INDIANA DEPARTMENT OF TRANSPORTATION

CONSTRUCTION MEMORANDUM 07-13

SUBJECT: House Enrolled Act 1623, Construction Signs

INDIANA DEPARTMENT OF TRANSPORTATION
 WORKSITE ADDED
 PENALTY SIGN

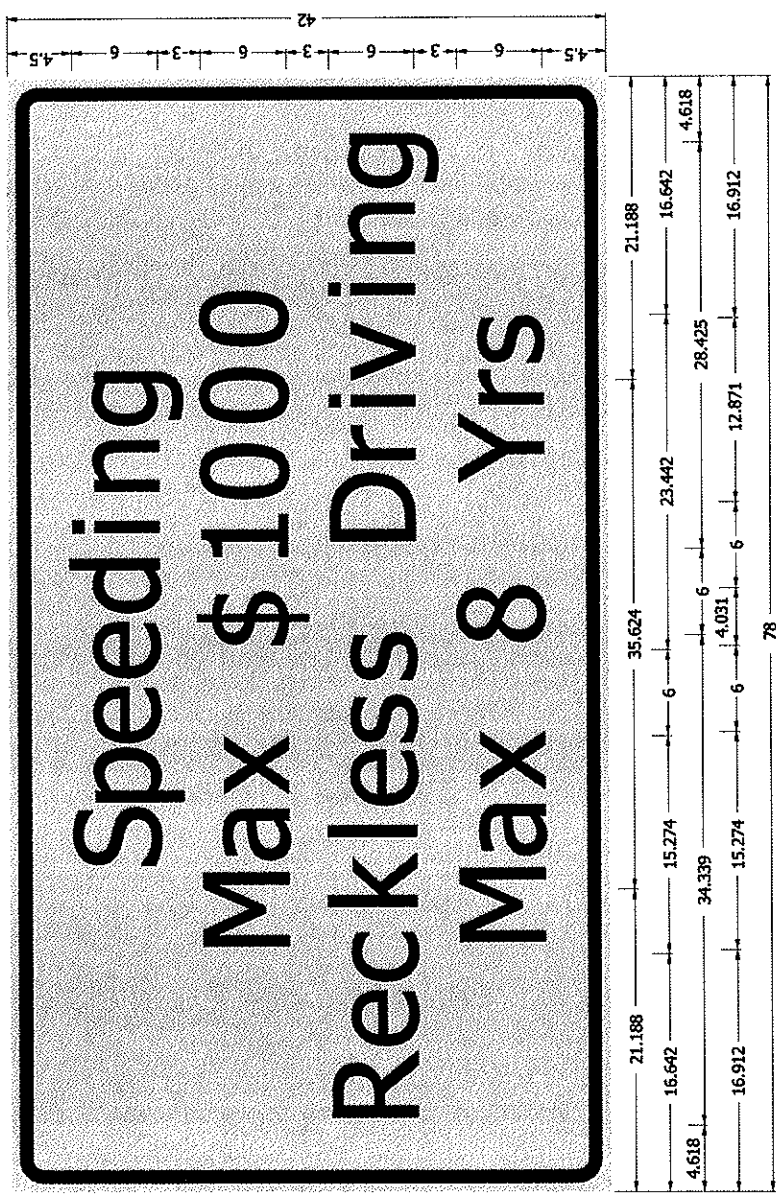
The legislation referenced above requires the Department to design and erect signs on all roadway work zones informing motorists of increased penalties for driving infractions. This requirement becomes effective July 1, 2007.

Contracts in future lettings will include bid items and quantities for these new signs; however, the signs must be installed on all active contracts also. Since this is not a standard drawing, the signs will be paid for as Type C signs per 801.04 of the Standard Specifications. The signs will be manufactured in accordance with the attached drawing.

A minimum of two signs will be required for each project. A sign should be placed in advance of the first Road Construction Ahead sign in each direction of travel on the mainline(s). The signs should be placed a distance of 500 feet in advance of the first RCA sign in rural areas, 100 feet in advance of the RCA sign in urban areas, or as directed by the Project Engineer/Supervisor. These signs will not be required on ramps or side streets. The PE/PS may contact District Traffic or the Work Zone Safety Section with questions concerning sign placement.

6 D UPPER AND LOWER; 2.250" Radius, 0.875" Border, 0.625" Indent, Black on Orange;
 [Speeding] D; [Max \$1000] D; [Reckless Driving] D; [Max 8 Yrs] D;
